Engineering Bulletin: **121601**

**Subject: 900RW Enhancements**

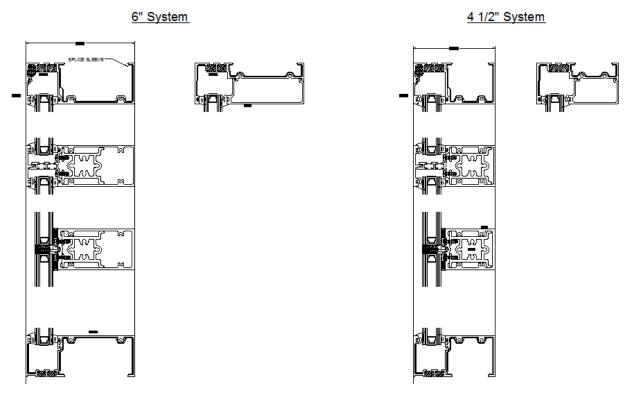
The 900RW Enhancement project is now complete. We have added splice sleeves for the head / sill frames to allow for continuous runs of SSG mullions. When the SSG mullions are used, the head / sill frames must run through. A maximum of 15' between splices is recommended. We have also added new shear blocked horizontal members that will work with the SSG mullions. These are available in both captured and SSG horizontals for the  $4 \frac{1}{2}$ " and 6" system depths. The captured horizontal is exterior glazed only and the exterior glass stop can span multiple lites up to a maximum of 15'.

Below are details showing the head / sill frames with the splice sleeves installed and the new horizontals.
